ENVIRONMENTAL REVIEW TEAM REPORT
ON
BEAR SWAMP ROAD SUBDIVISION
EAST HAMPTON, CONNECTICUT
JULY, 1976

**BEAR SWAMP ROAD
SUBDIVISION**
EAST HAMPTON, CONNECTICUT

ENVIRONMENTAL REVIEW TEAM REPORT
ON
BEAR SWAMP ROAD SUBDIVISION
EAST HAMPTON, CONNECTICUT

TOPOGRAPHY AND SURFICIAL GEOLOGY

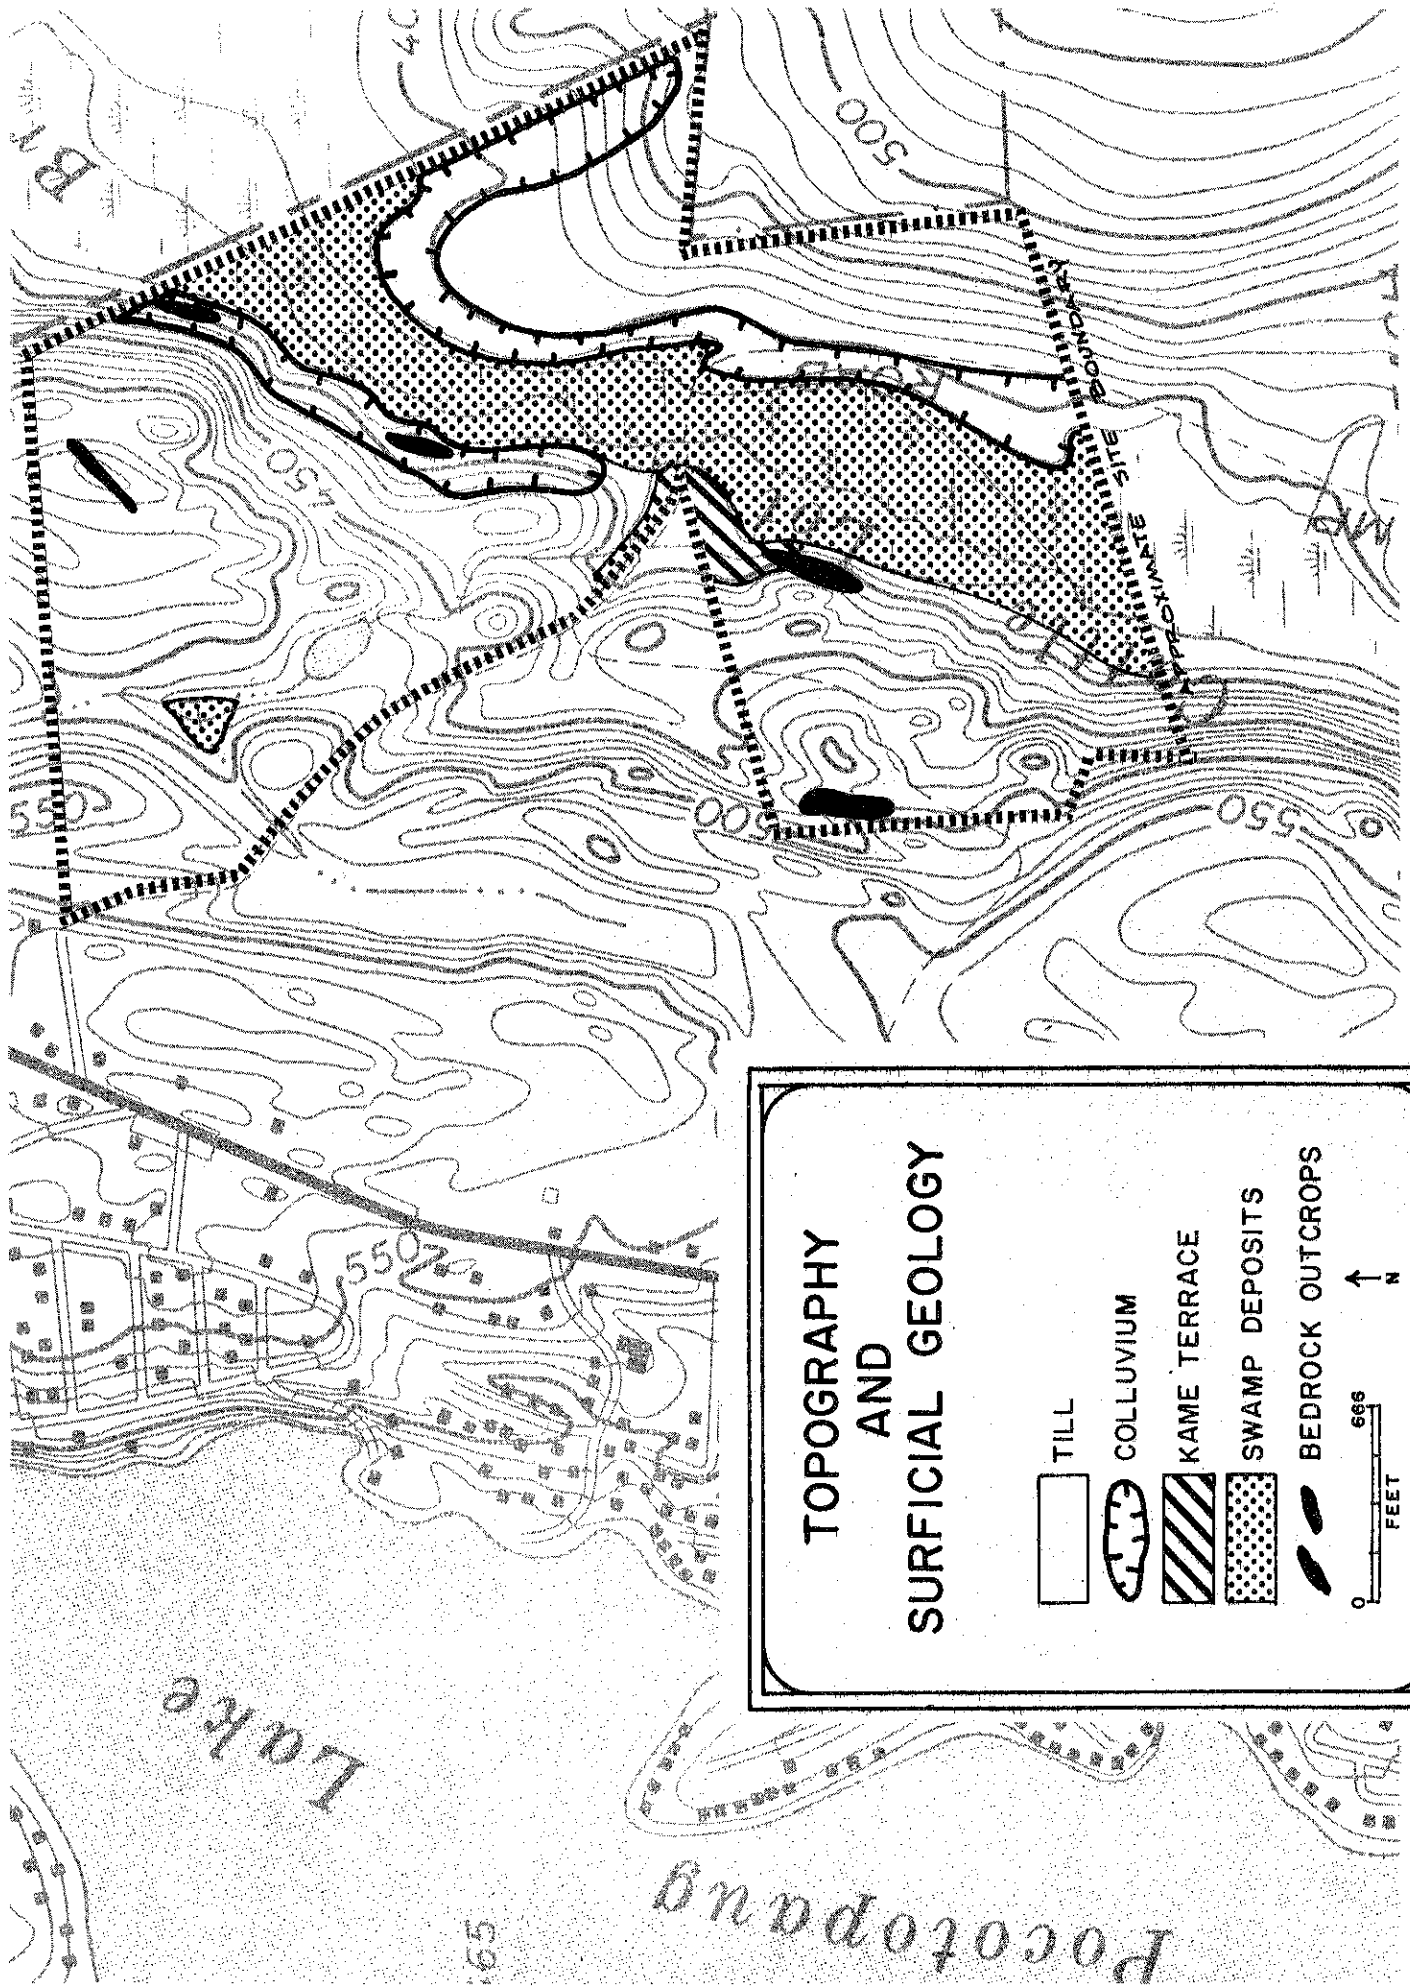
As indicated on the Topography and Surficial Geology Map, there are numerous outcrops located on the west side of Cattle Lot Brook. This area is extremely shallow to bedrock. The map only indicates areas of large outcroppings, many smaller ones were located during the field review. Although the shallow bedrock surface make excellent bases for foundations, they do create problems in design of subsurface sewage disposal and in the placement of onsite water supply wells. Possible further investigation may be needed when designing in shallow bedrock areas.

**FLOOD
PRONE
AREA**

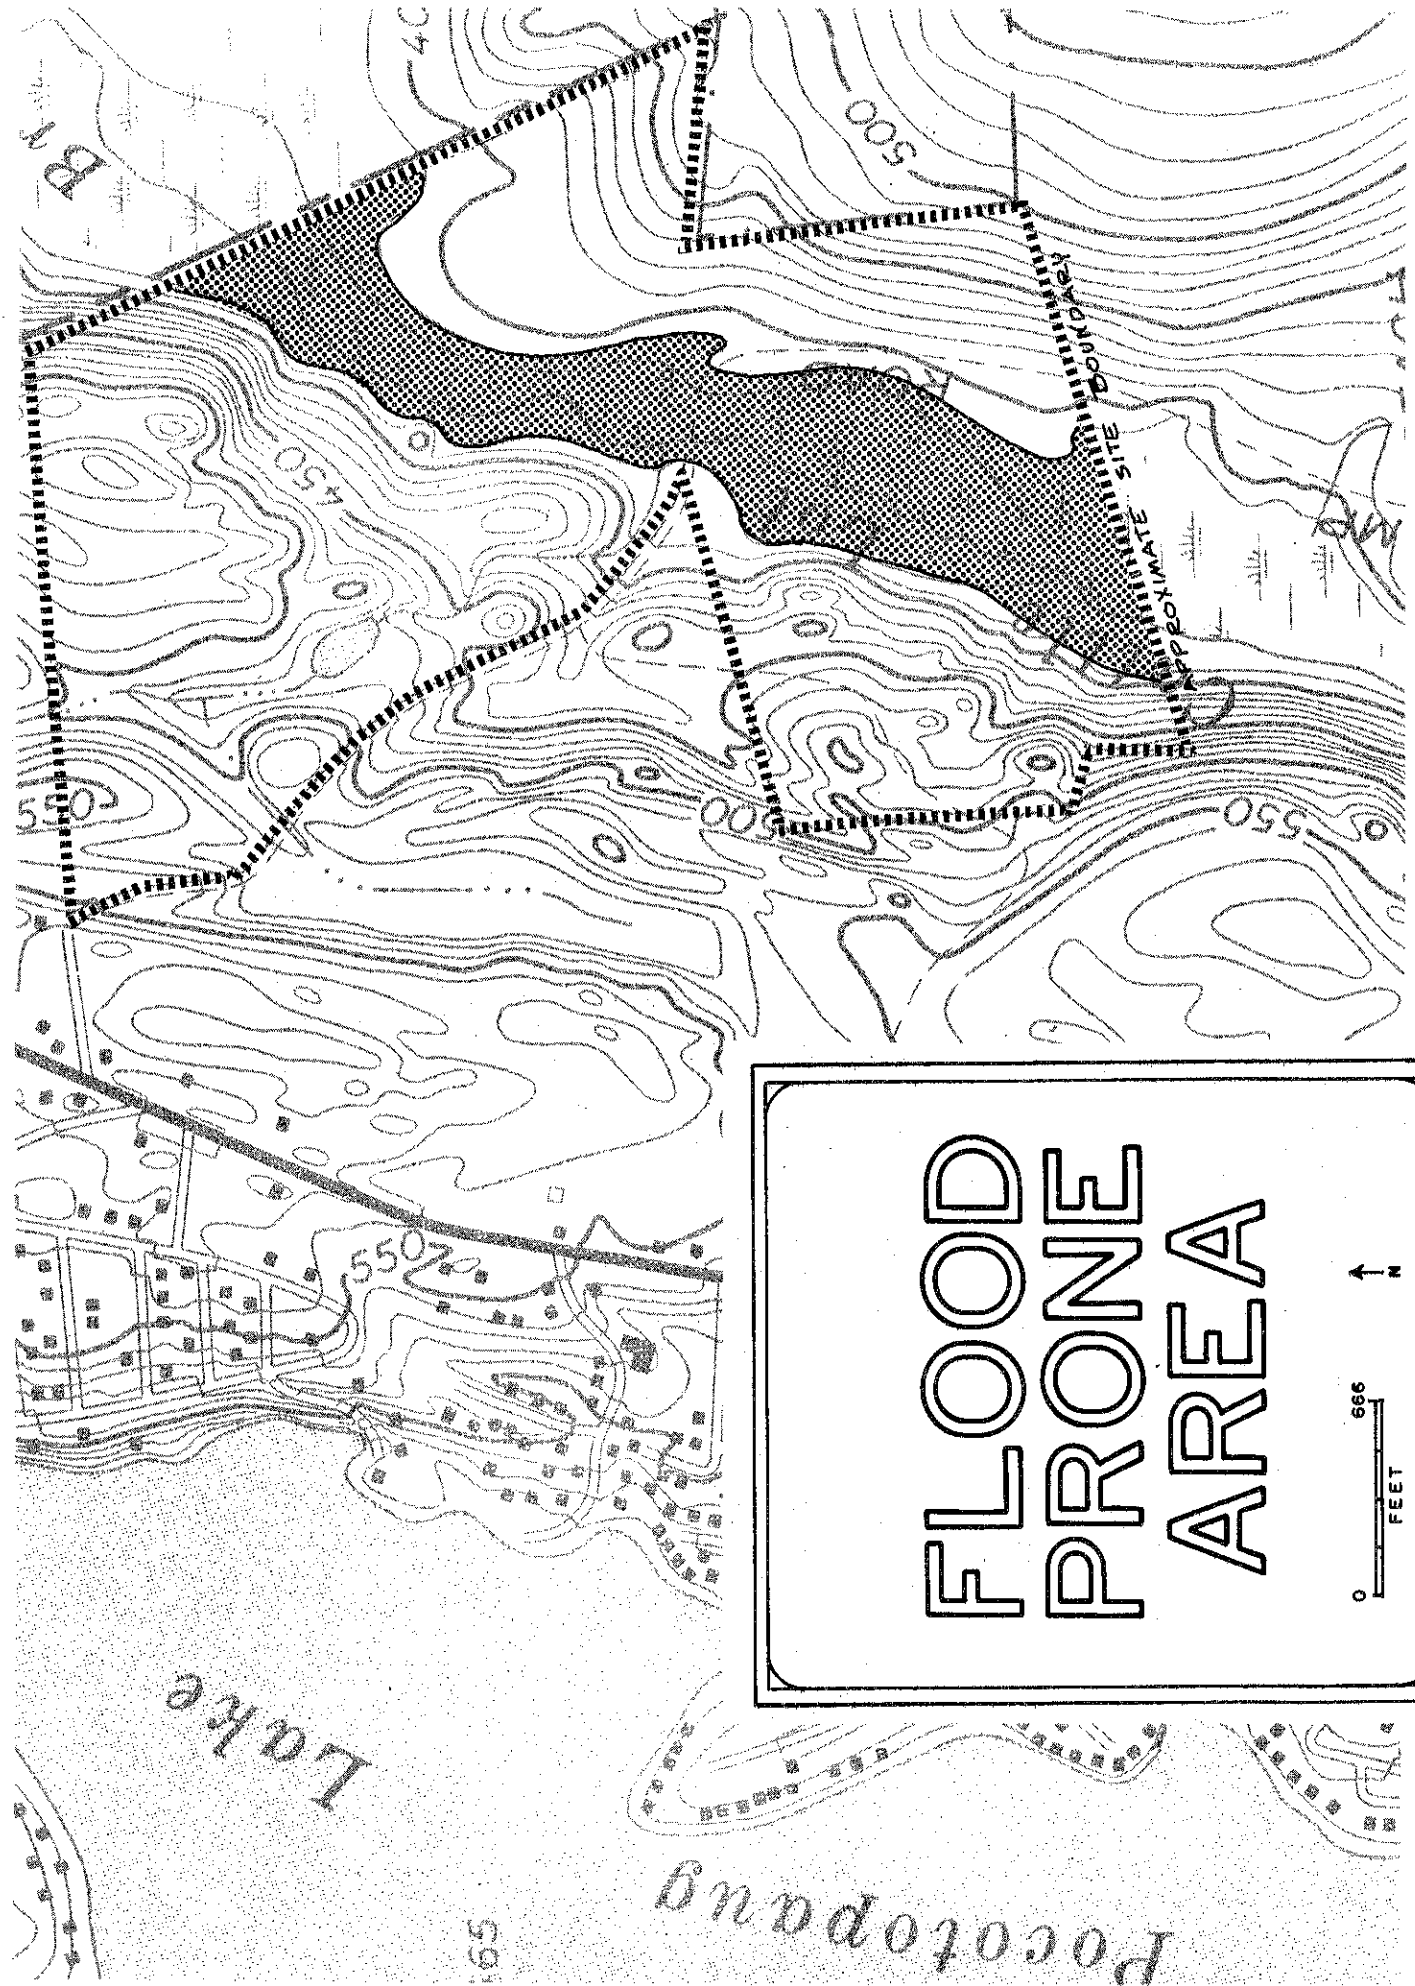
The site investigated lies approximately in the central portion of the Cattle Lot Brook drainage area. The area encloses approximately 2.0 square miles. The flow of Cattle Lot Brook is in a general northeast direction. The low flow value of the brook through the site was not calculated. This value should be investigated further though as any planned development around the wetland area may effect the low flow value. The extent of the area potentially subject to flooding is shown in the Flood Prone Area map. According to source material from the United States Geologic Survey (USGS), the area indicated as flood prone has a one in 100 years recurrence level, meaning that at least once in 100 years the flood water will probably reach the level indicated. Of course, it should also be noted that this is a statistical flood level and that the levels indicated can occur twice in one year or for two successive years or more. A study of soils types will give a good indication as to normal yearly flooding. For safety, the one in 100 years flood level should be used for all design plans.

SOIL MAP

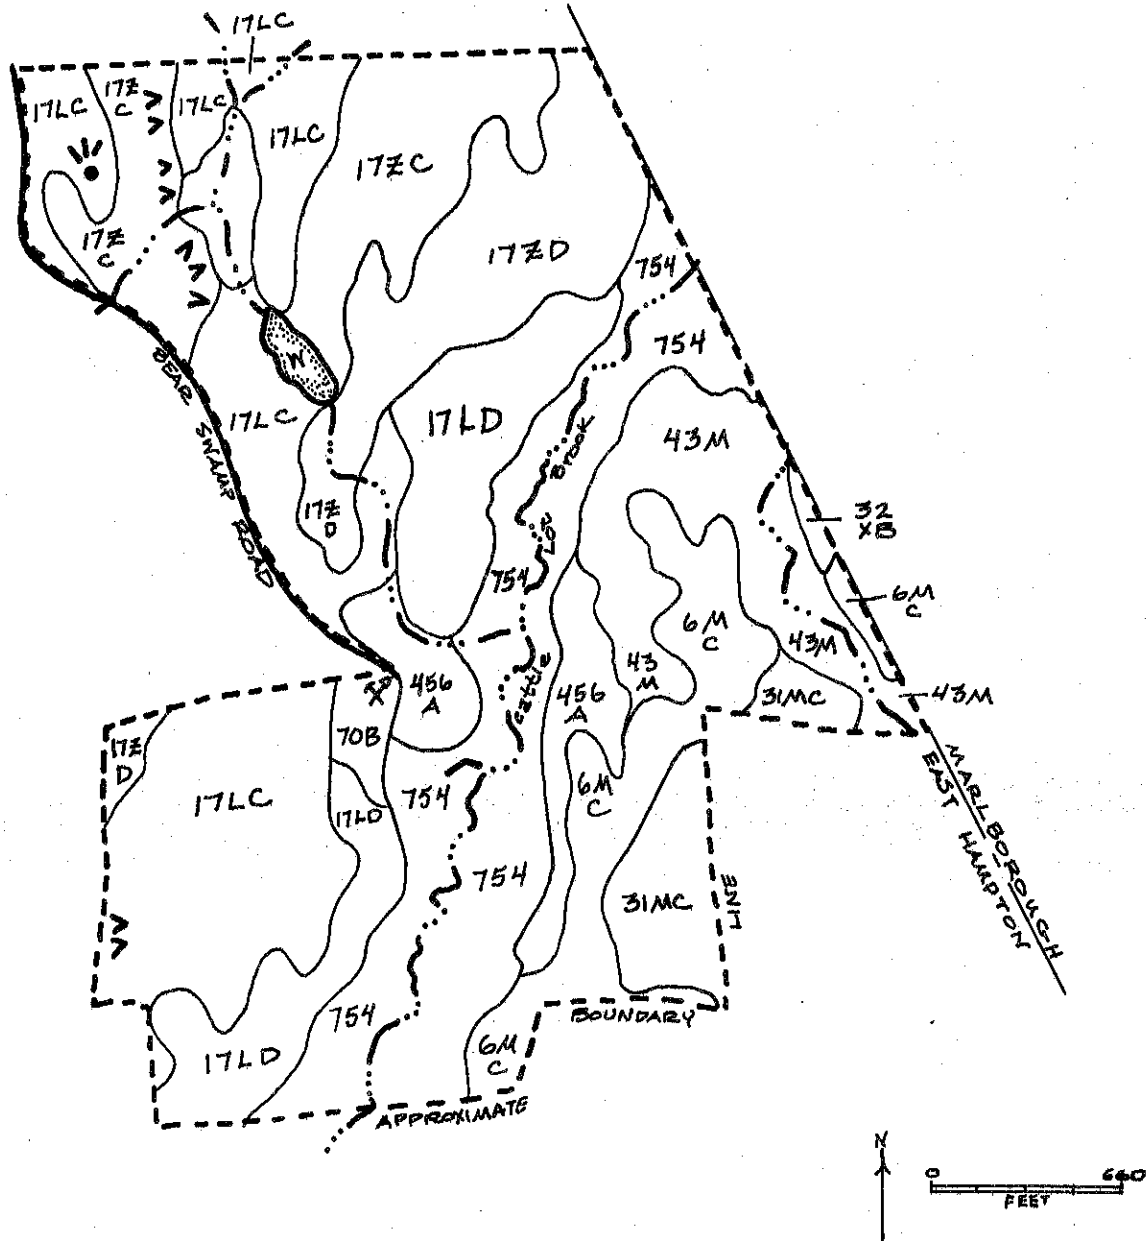
Referring to the soil map and soils limitations chart, approximately 98.5 acres are Hollis-Charlton or Hollis-Charlton outcrop soils characterized by steep slopes, bedrock outcrops, and a general shallow depth to bedrock. These soils

present severe limitations for on-site sewage disposal systems, basement construction, and other uses listed in the chart. The bedrock is typically less than two feet below the land surface, with numerous bedrock outcrops (exposed rock surfaces) as were observed during the field inspection. Due to the considerable amount of land having a shallow to bedrock condition, acceptable soil locations for septic systems should be determined before individual house lots are established on a site plan. Within these Hollis-Charlton soils it should be understood that there can be pockets of deep soil which, if found, can provide acceptable locations for development, probably individual house sites. These pockets can tend to be difficult and costly to locate, and may be widely spaced as the site contains areas of very steep slopes (greater than 15%) as well as a somewhat irregular topography in the northwest and southwest portions.

Approximately 52.5 acres of land around the major watercourses and intermittent streams of the site are wet soils such as Scarborough, Sudbury, and a Ridgebury and Whitman unit. The Scarborough (754), and Ridgebury and Whitman unit (43M) soils are very poorly drained. The water table in these soils is normally at or near the surface from late fall through late spring, but may drop below 6 feet during the summer months. It is advisable then not to take percolation tests in these soils during the summer months. The 43M soil is usually occupying low-lying nearly level to very gently sloping areas, while the 754 soil is usually found in low-lying flat or depressed areas. The Sudbury (456A) soil is moderately well drained, however, mottling appears at 14 to 20 inches in depth indicating waterlogging in wet seasons.
